HISTORIC AND DESIGN REVIEW COMMISSION

HDRC CASE NO: 2018-631
ADDRESS: 321 N HACKBERRY ST
LEGAL DESCRIPTION: NCB 583 BLK 8 LOT 11
ZONING: IDZ, H
CITY COUNCIL DIST.: 2
DISTRICT: Dignowity Hill Historic District
APPLICANT: Roberto Elizondo
OWNER: Gabriela and Abel Marin
TYPE OF WORK: Construction of two, multi-family residential structures
APPLICATION RECEIVED: December 13, 2018
60-DAY REVIEW: February 11, 2019

The applicant is requesting conceptual approval to construct two, two and a half story, multi-family residential structures on the vacant lot at 321 N Hackberry within the Dignowity Hill Historic District.

SITE PLAN

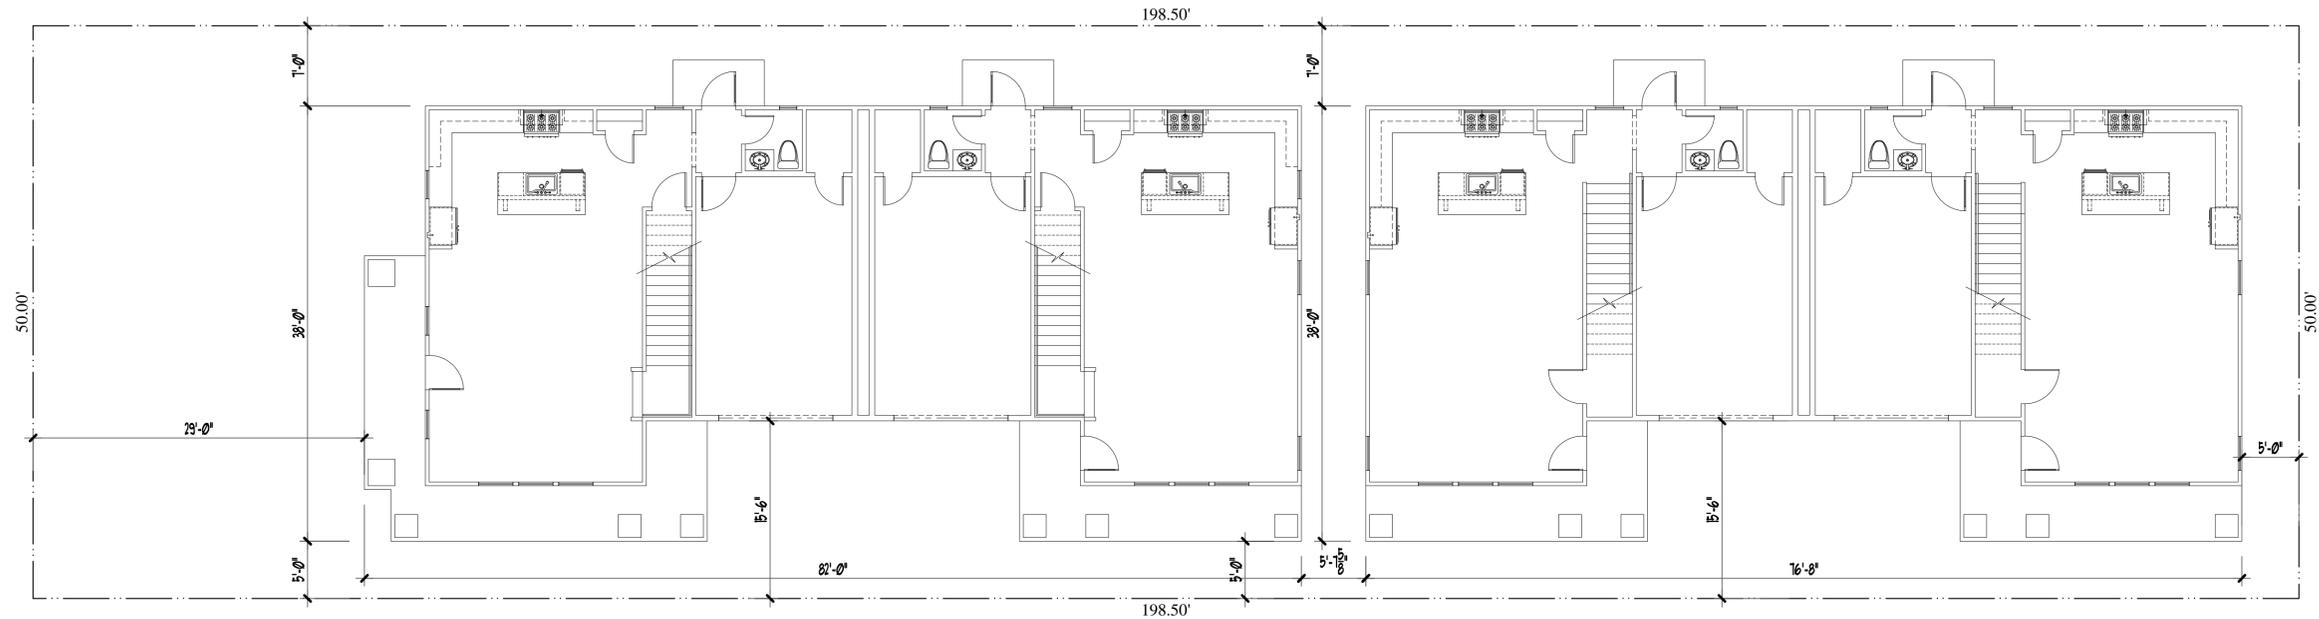
- c. **SETBACKS & ORIENTATION** – According to the Guidelines for New Construction, the front facades of new buildings are to align with front facades of adjacent buildings where a consistent setback has been established along the street frontage. Additionally, the orientation of new construction should be consistent with the historic examples found on the block. This block of N Hackberry features two historic structures on the west block face that front N Hackberry. The applicant has noted a setback of 29’ – 0” from the property line. The adjacent historic structure features a setback of approximately thirty (30) feet. The applicant should submit a site plan noting the footprint of the adjacent historic structure confirming that the proposed new construction features a greater setback.

- i. **LOT COVERAGE** – Per the Guidelines, the building footprint for new construction should be no more than fifty (50) percent of the size of the total lot area. The applicant has proposed to introduce a large amount of square footage that currently is not typical of the district. Per the applicant’s site plan, the lot features 9,915 square feet. The applicant has proposed a total footprint of approximately 5,500 square feet, covering approximately 55% of the lots square footage. While inconsistent with the Guidelines, staff finds the proposed new construction to be appropriate given the size and depth of the lot.

- i. That the applicant confirm that the proposed setback from N Hackberry is greater than that of the neighboring historic structure as noted in finding c.

LOWER LEVEL FLOOR PLAN

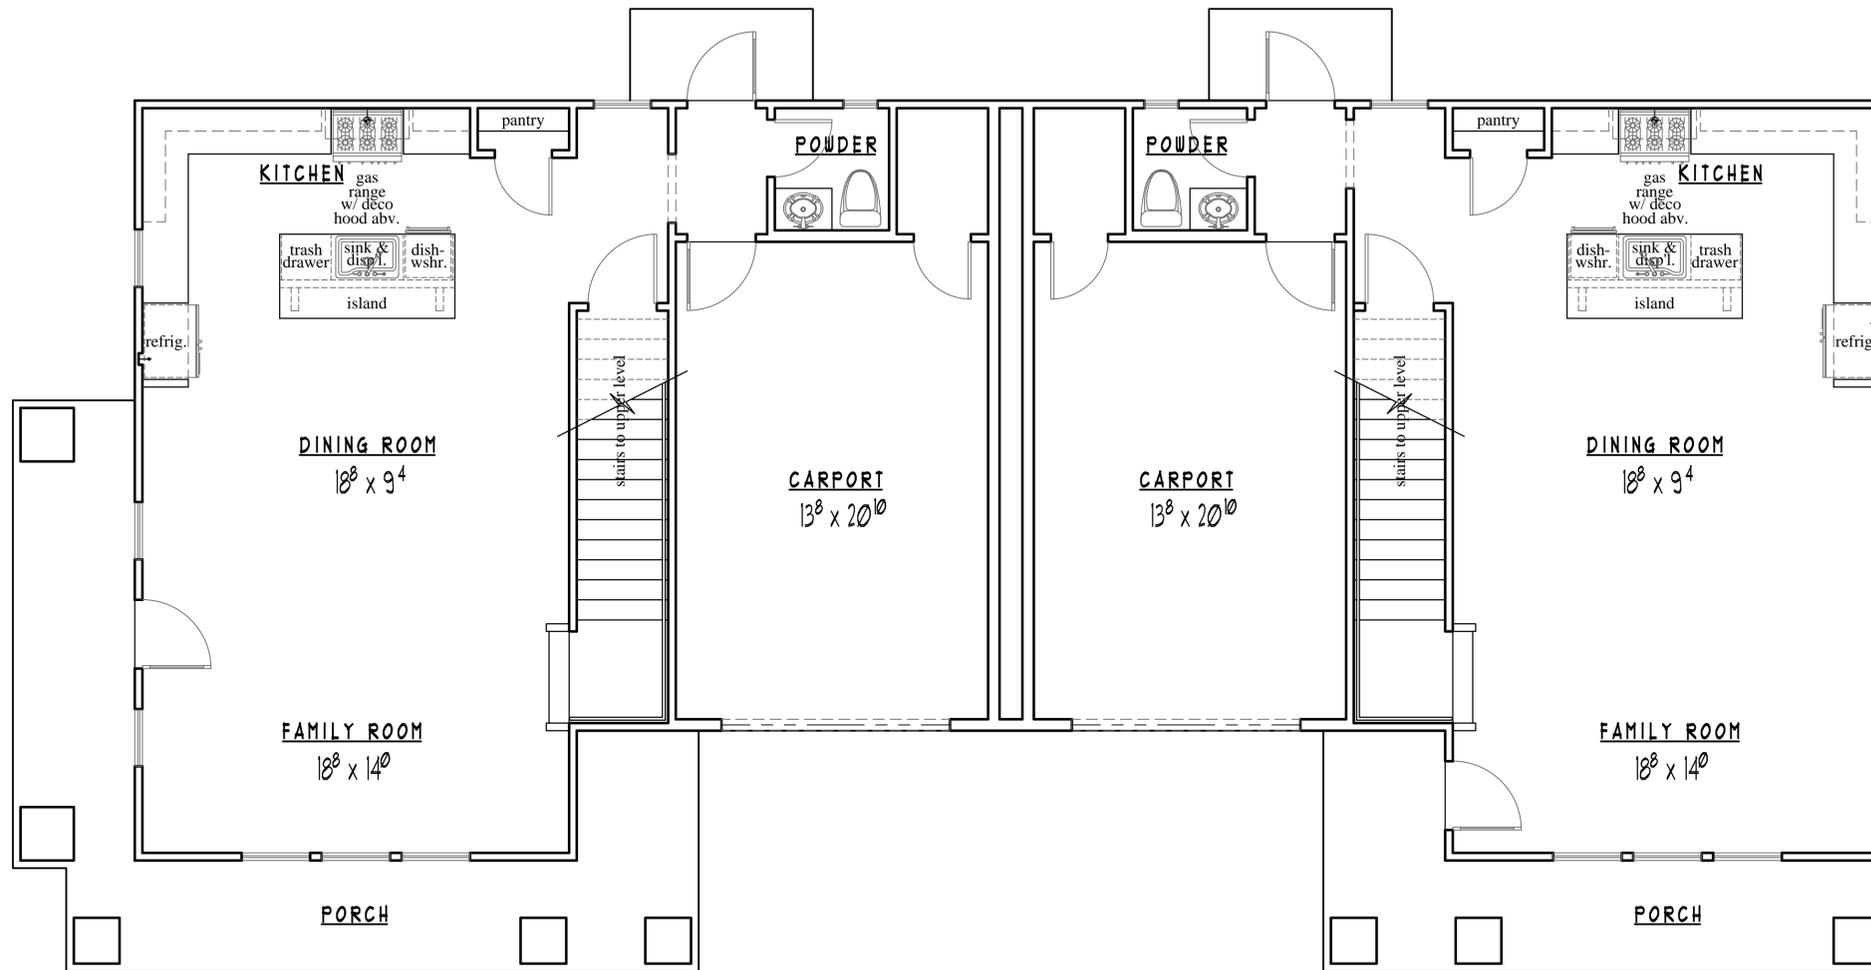
- m. ARCHITECTURAL DETAILS (Massing) – While staff finds the proposed height to be appropriate, the applicant has proposed a separation between the massing of each unit; however, both units share a roof mass. Staff finds that the proposed units should be detached.

- n. ATTACHED PARKING – The applicant has proposed attached garages that are to feature garage door openings on the north façade. Attached garages are not found historically within the Dignowity Hill Historic District. Generally, staff finds that the proposed attached parking should be separated from the primary mass of the residential structure.

Staff does not recommend conceptual approval at this time. Staff finds that the applicant should separate the massing of the proposed structures as noted in finding m and remove the proposed garages from the massing of the residential structures as noted in finding n prior to receiving conceptual approval. Additionally, staff recommends that the applicant address the following:
